UNITED STATES PATENT AND TRADEMARK OFFICE

| APPLICATION NO. | FILING DATE | FIRST NAMED INVENTOR | ATTORNEY DOCKET NO. | CONFIRMATION NO. |
|-----------------|-------------|----------------------|---------------------|------------------|
| 10/549,467 | 04/04/2006 | Stefan Stowe | WET 0129 PCT | 8328 |

| Office Action Summary | Application No. 10/549,467 | Applicant(s) STOWE, STEFAN | |

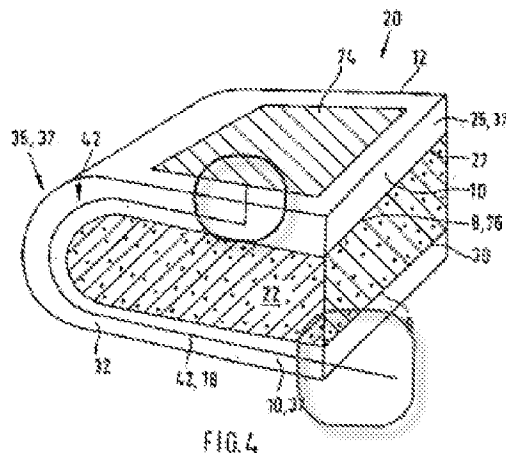
4. The drawings are objected to because Figure 4 is unclear as to what is shown. As seen below, the drawing contains a line extending outward from the lower part of the figure as well as a line extending up from middle of the upper air distribution device. Corrected drawing sheets in compliance with 37 CFR 1.121(d) are required in reply to the Office action to avoid abandonment of the application. Any amended replacement drawing sheet should include all of the figures appearing on the immediate prior version of the sheet, even if only one figure is being amended. The figure or figure number of an amended drawing should not be labeled as "amended." If a drawing figure is to be
